**MEETING OF THE
PLANNING AND ZONING BOARD
QUASI-JUDICIAL PUBLIC HEARING**

September 20, 2016

ITEM: Request for approval for a new multi-family dwelling for "Beau Rivage Condominium" located at 9781 E. Bay Harbor Drive, Lot 28 of Block 4. The developers are proposing to construct a nine (9) unit mid rise development. On August 2, 2016 the Board deferred the project and advised the applicant to make several changes. The developer has submitted the revisions. The proposed units range from 1,601 to 4,036 sq. ft. of a/c plus balconies, etc. The proposed design incorporates one rectangular shaped building positioned on top of a one-story parking garage structure. The building has 8 stories in height (7 floors of residential over 1 story parking garage / common areas) @ max. 75 feet above BFE. No TDR's will be required. Enclosed please find the site plan and elevations. (Item #2A)

Subject: Site Development Plan Application
Beau Rivage Condominium – New 2016 Proposal – 2nd Review
9781 East Bay Harbor Drive
Bay Harbor Islands Acct. No. MB2016-43
MMPA Acct. No. 01-0702-0906C

0A-02

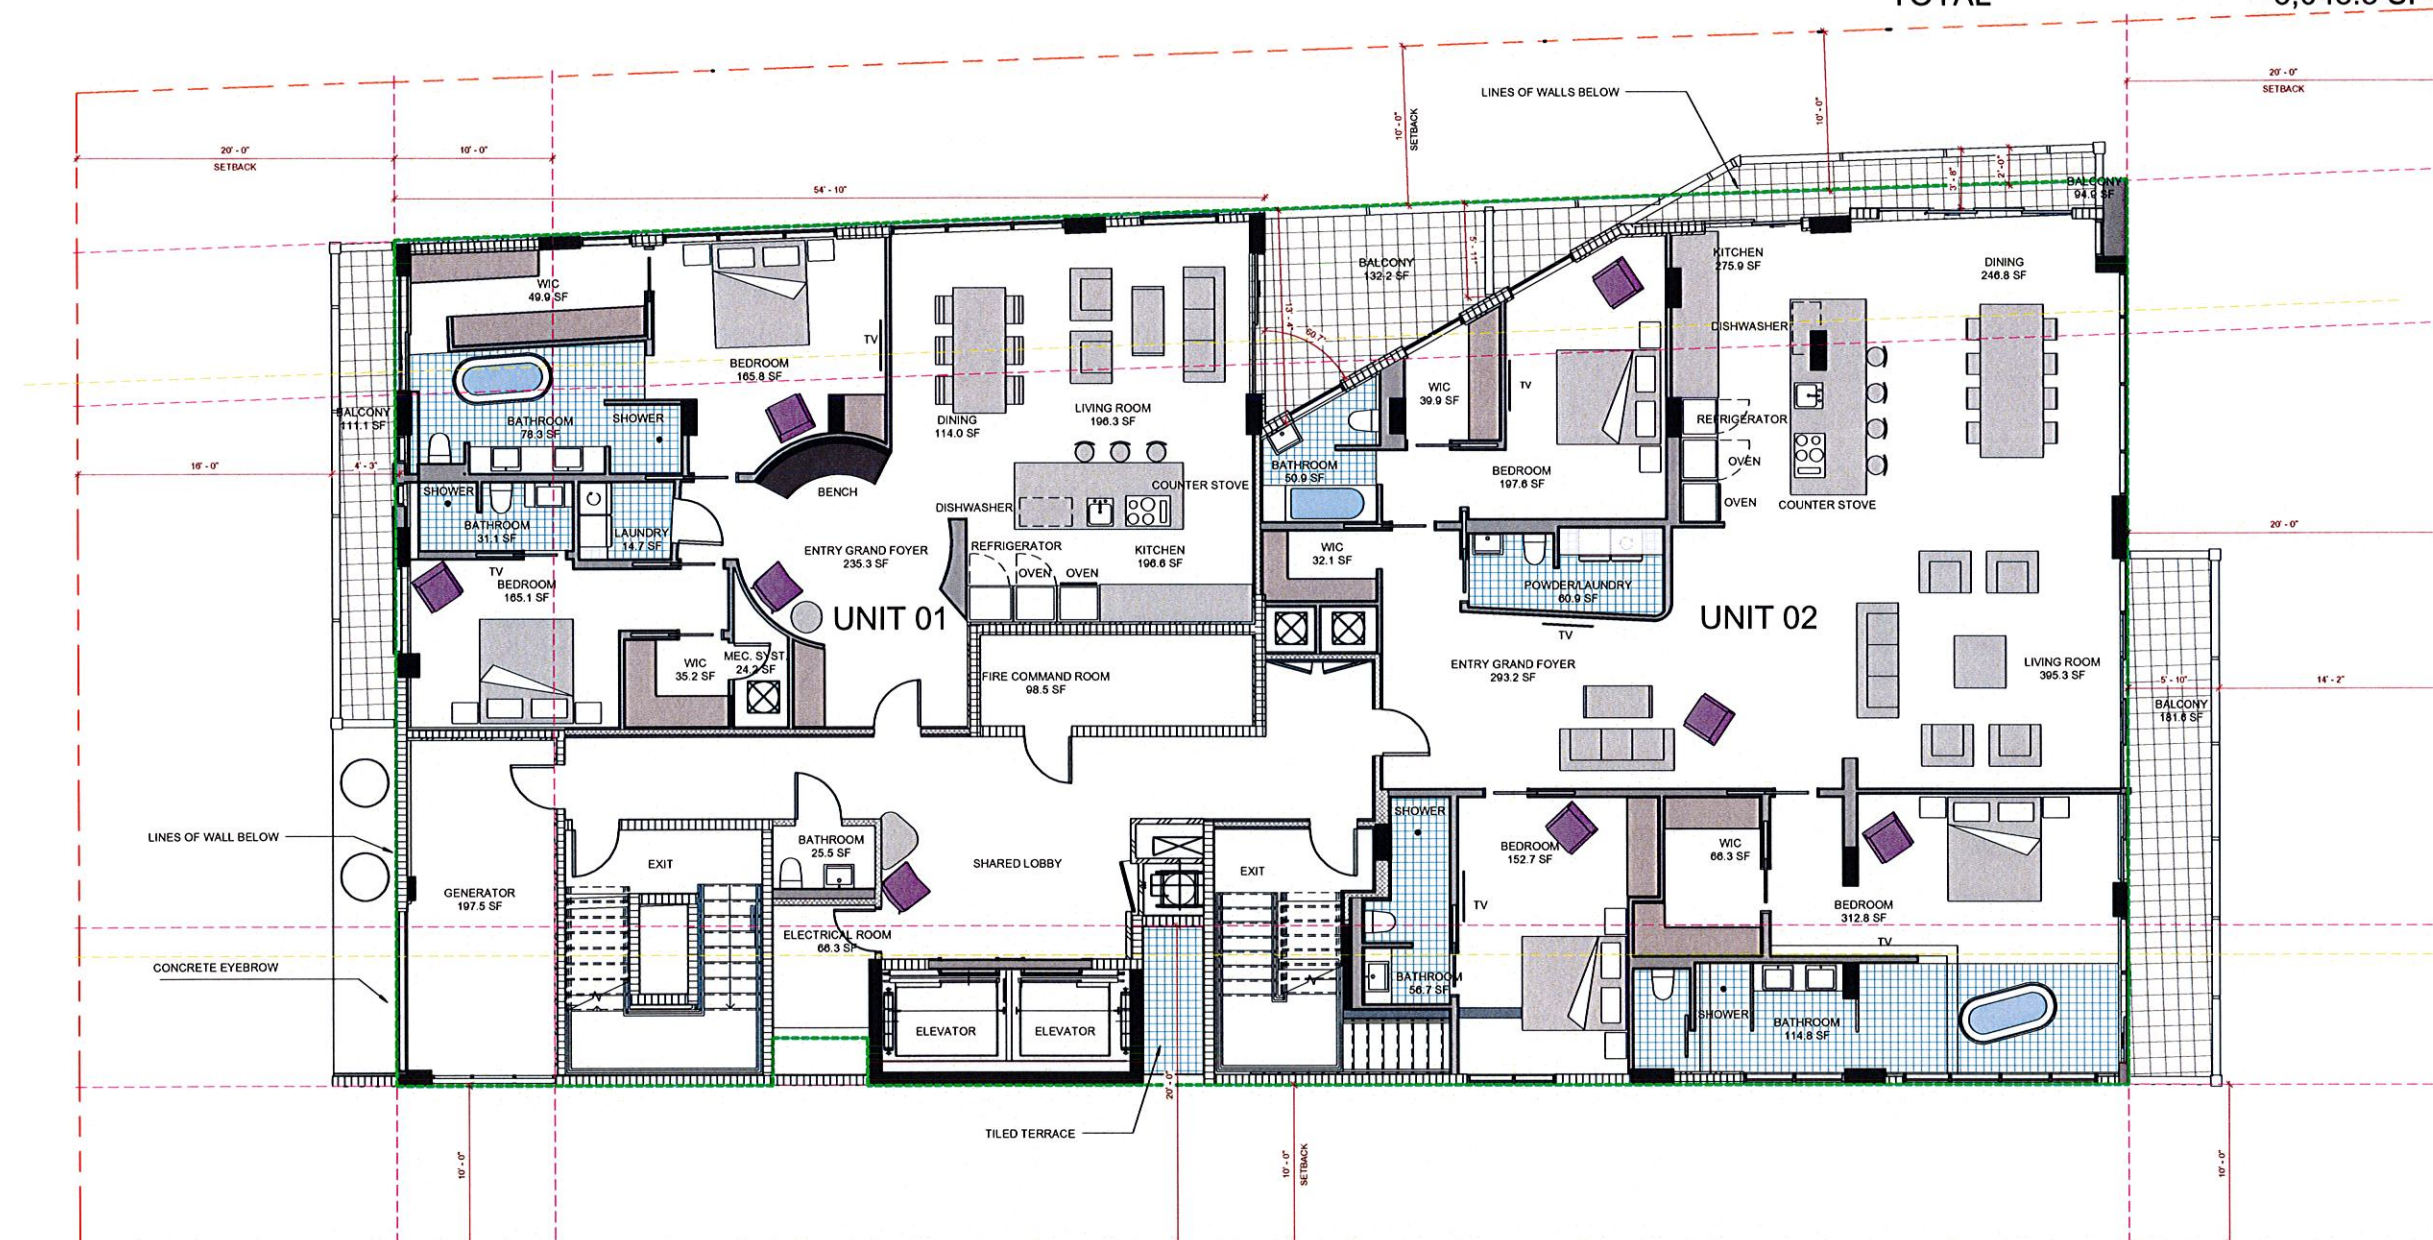
- MODIFY ENTRANCE TO PROVIDE COVERING TO LOBBY, CONTINUE BALCONY FROM ABOVE (EYEBROW), AND MAKE THE GLASS OPENING THE SAME WIDTH AS ABOVE-REFER TO SHEETS OA-2, OA-3, OA-4, OA-22

- 3. *Provide a covering over lobby entrance.***
The applicant has provided a canopy / eyebrow over the entrance area.
- 4. *Shift the trash enclosure away from the street and shift the transformer toward the side property line.***
The applicant has revised the plans to address these concerns.

0A-09

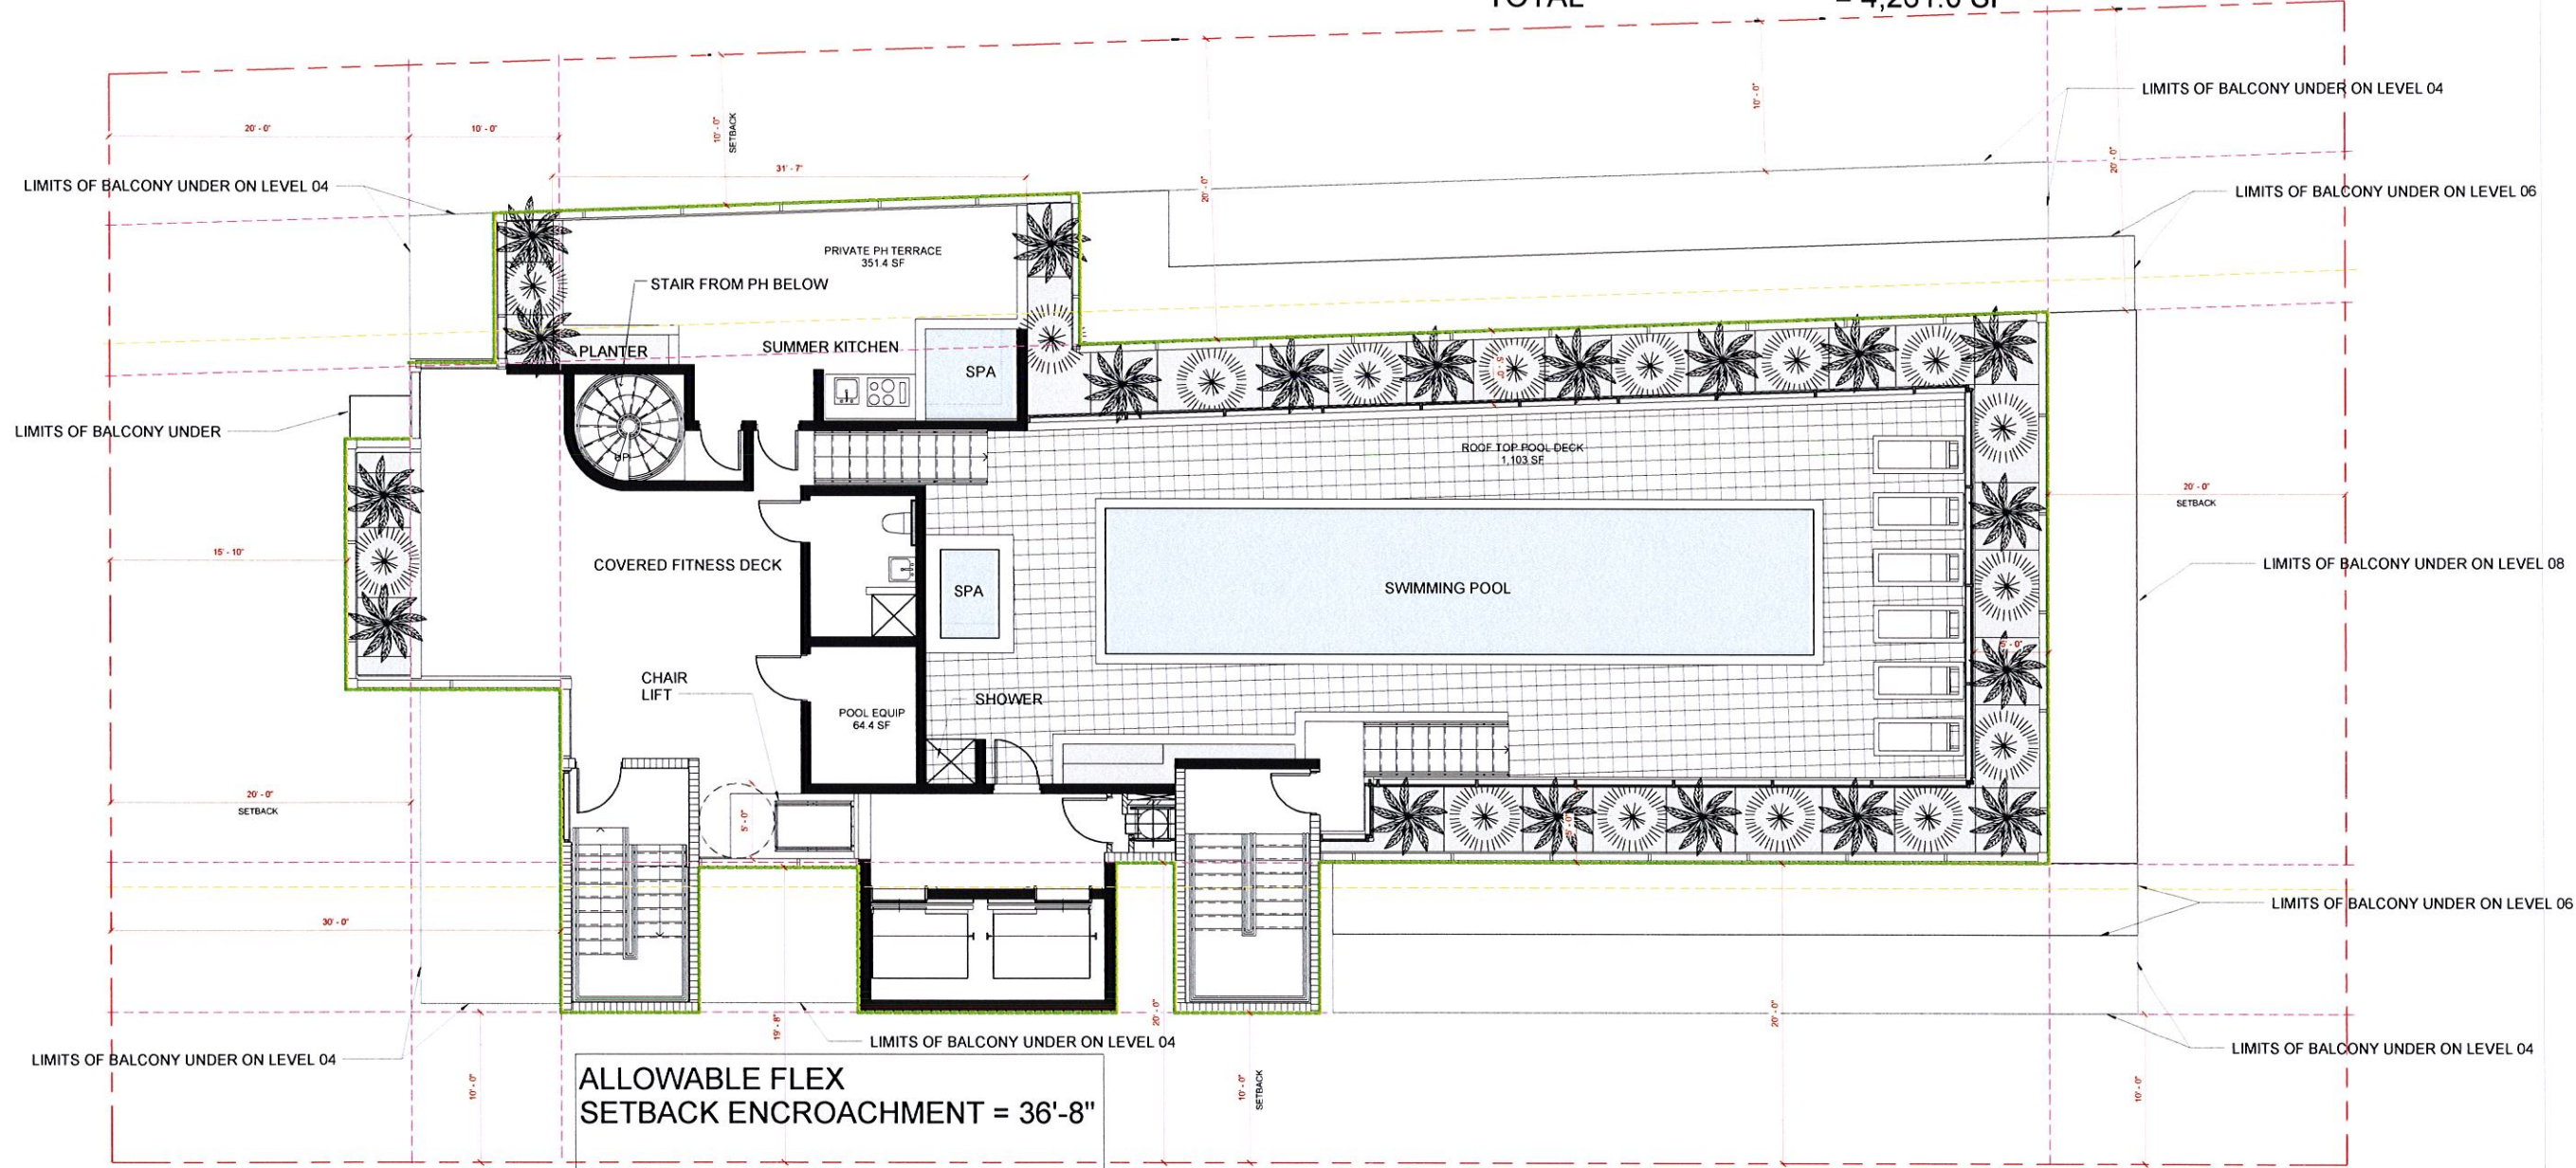
- ADD CIRCULAR/SPIRAL STAIR IN PENTHOUSE UNIT TO ROOFTOP TERRACE-REFER TO SHEETS OA-09 & OA-22
- REPLACE SOLID ROOF COVERINGS FOR FITNESS AREA WITH TRELLIS AND TRY TO LOWER STAIR BULKHEAD TO MATCH HEIGHTS-REFER TO SHEETS OA-09B AND OA-22

- 5. *Revise the fence detail and elevations to be consistent.***
The applicant has revised the elevations to match the fence detail.
- 6. *Revise the access to the roof from the penthouse and revise the roof coverings over the fitness area.***
The applicant has revised the roof plan to address the Board’s concern.

ELEVATION -
west/east
0A-22

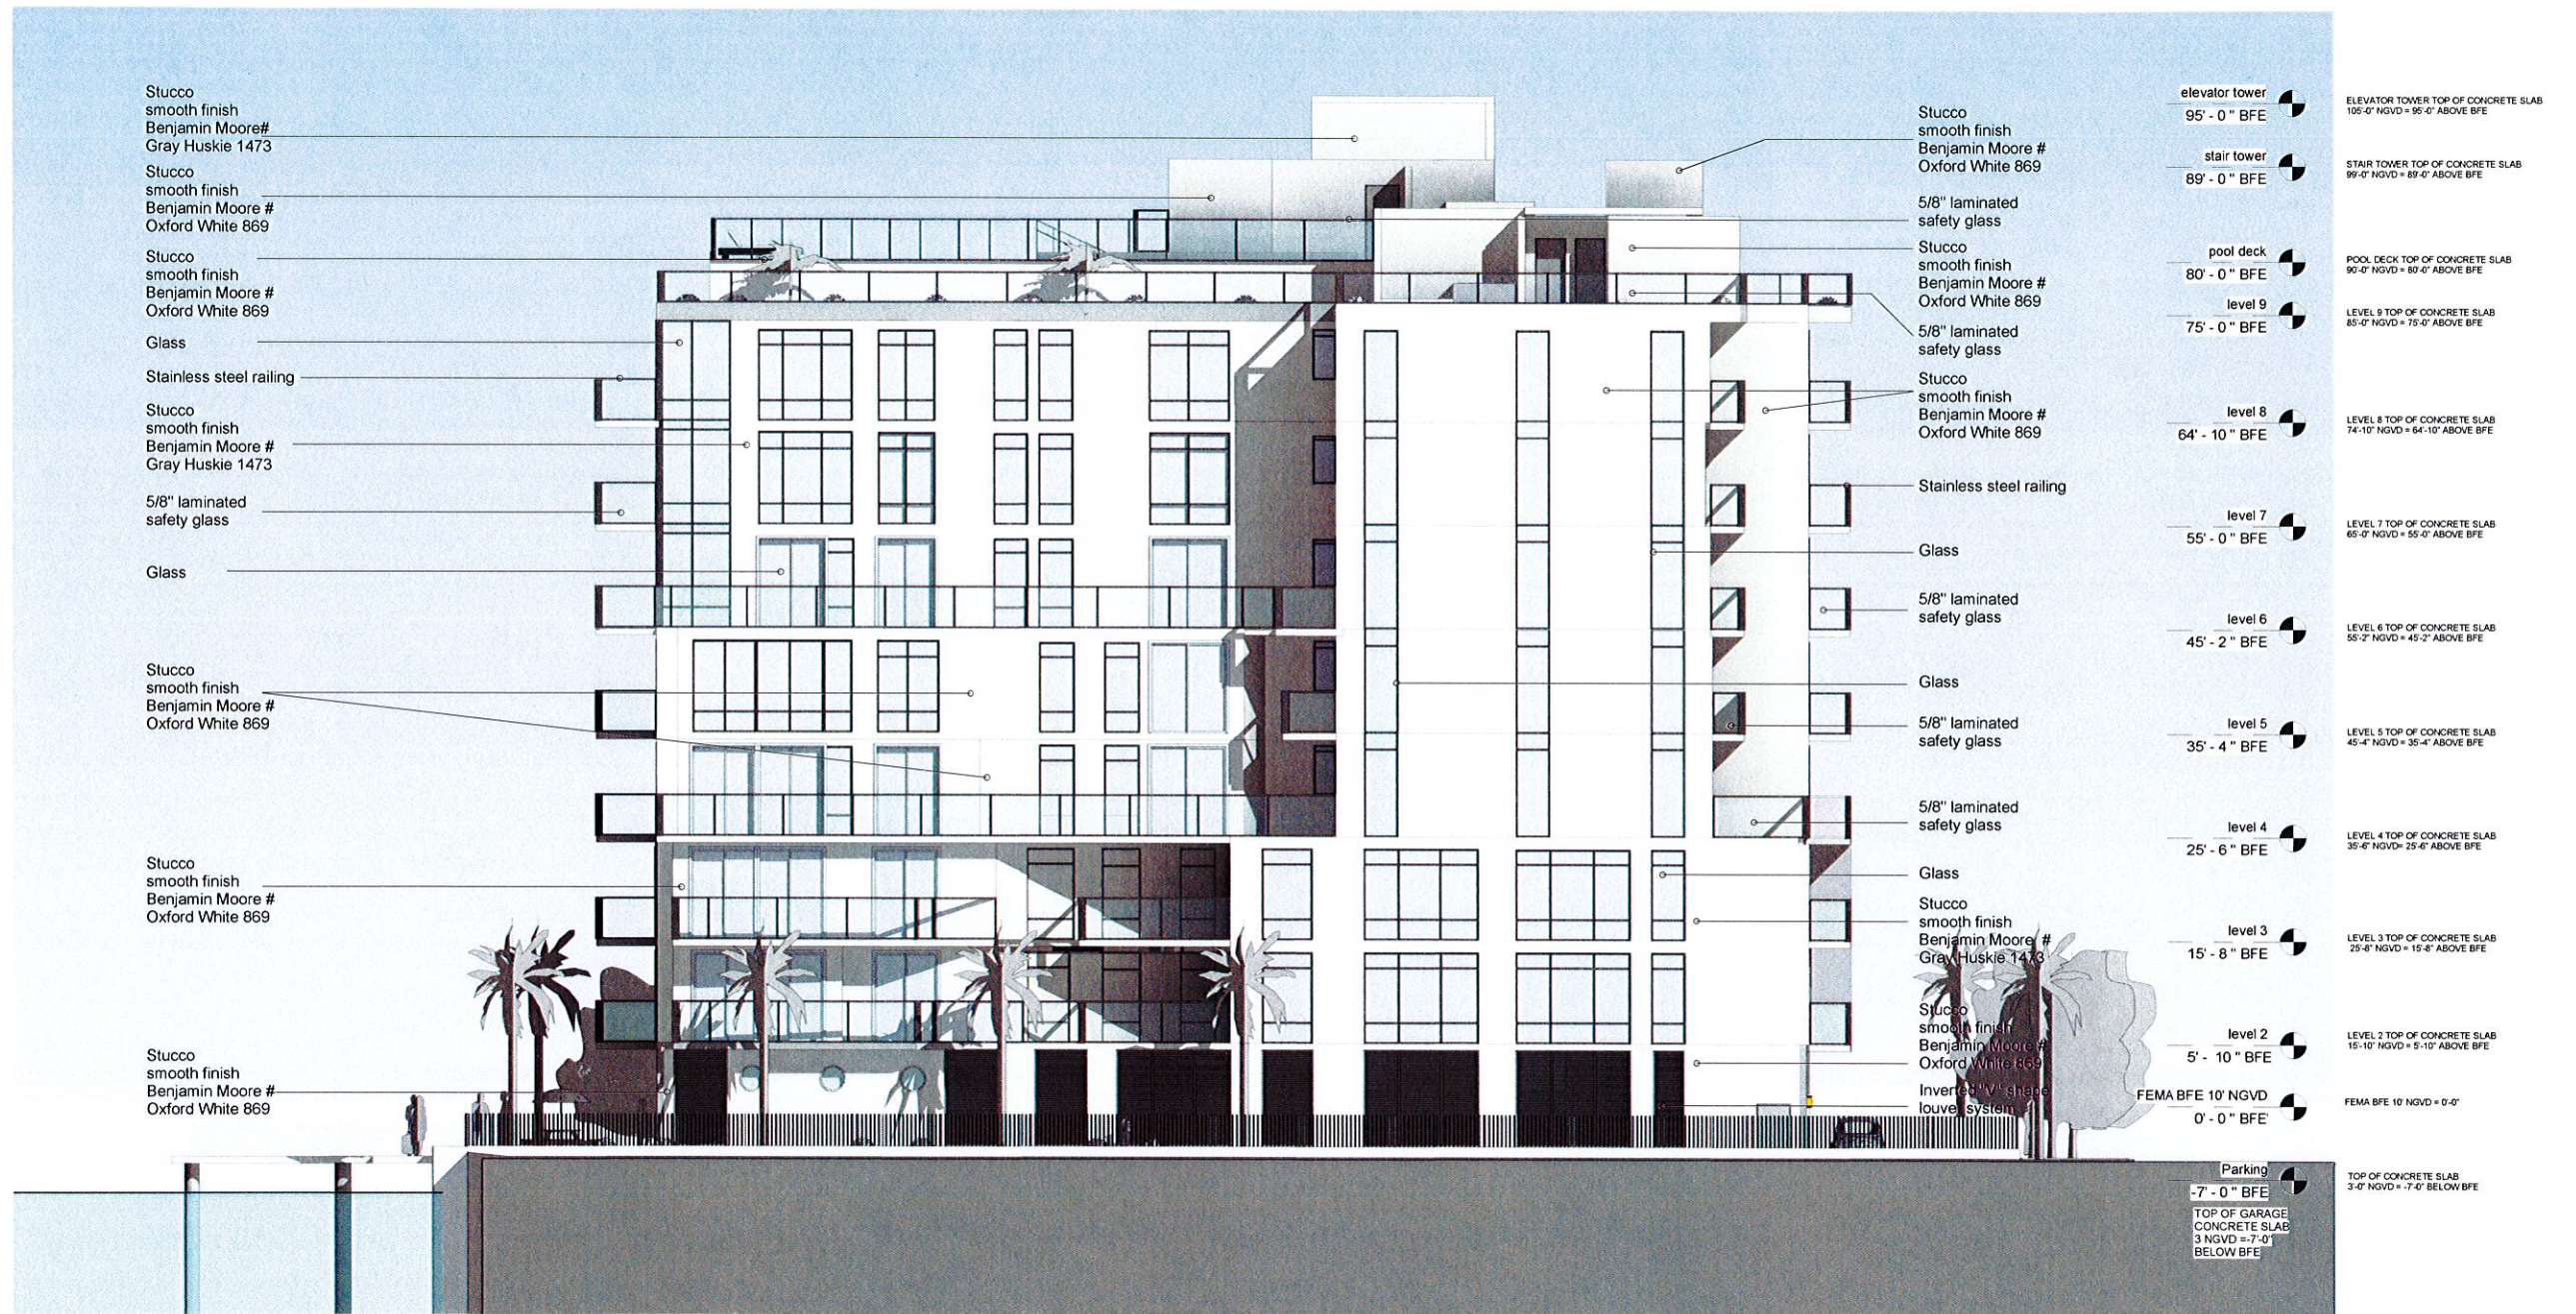
- REDESIGN EAST FAÇADE AT GARAGE LEVEL TO MAKE IT LOOK LESS LIKE A GARAGE DOOR AND INTRODUCE LOUVERS THAT WRAP FROM EAST TO NORTH
- SIDE AS A BAND-REFER TO SHEET OA-22

- EXPRESS VERTICAL LINES ON EAST ELEVATION TO CARRY DOWN GLAZING FROM ABOVE TO GROUND LEVEL-REFER TO SHEET OA-22
- EXPRESS VERTICAL LINES ON LOUVERS ON NORTH AND SOUTH ELEVATIONS FOLLOWING GLAZING FROM ABOVE-REFER TO SHEETS OA-23 & OA-24

- ALSO FOR WEST ELEVATION, CONTINUE THE HORIZONTAL LOUVERS FROM NORTH TO WEST-REFER TO SHEET OA-22
- FENCE DETAIL IS AS SHOWN ON SHEET A25. CHANGE IN ELEVATIONS TO MATCH-REFER TO SHEET OA-24

- 1. *Redesign the East façade to remove the garage door look, add louvers and express vertical lines.***
The applicant has redesigned the façade to address these issues.
